# Access Compliance Report

## Public Rights-of-Way

### (Curb Ramps)

| Intersection ID: N/A | Main Street: COUNTRY_WALK_DR | Cross Street: NATURE_WALK_DR | Location: E            |

| ADA ID: DCA7400E7AE3 | Ramp Type: PerpDiag          | Initial Pass/Fail: Fail      | Overall Compliance: No |

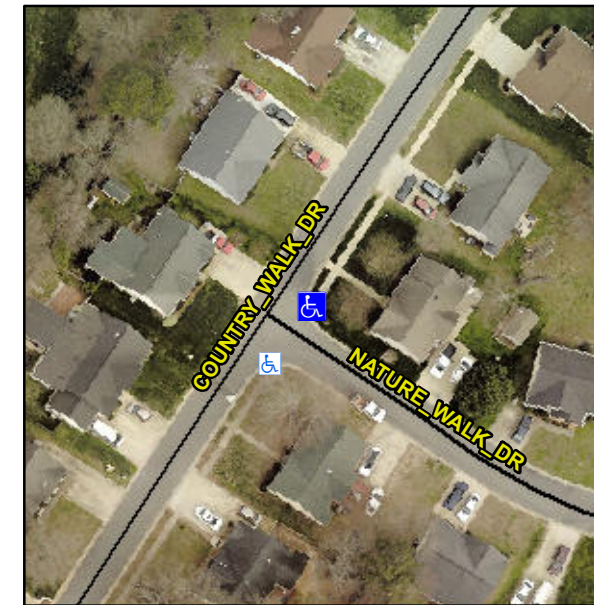
**Not Found, R304.5.1**

| Compliance | Description           | Data  | Compliance | Description                 | Data  |
|------------|-----------------------|-------|------------|-----------------------------|-------|
| No         | Ramp Width (in)       | 40.0  | Yes        | Ramp XSlope (%)             | 2.8   |

**Remove & Replace Curb Ramp With Two New Directional Ramps or Equivalent.**
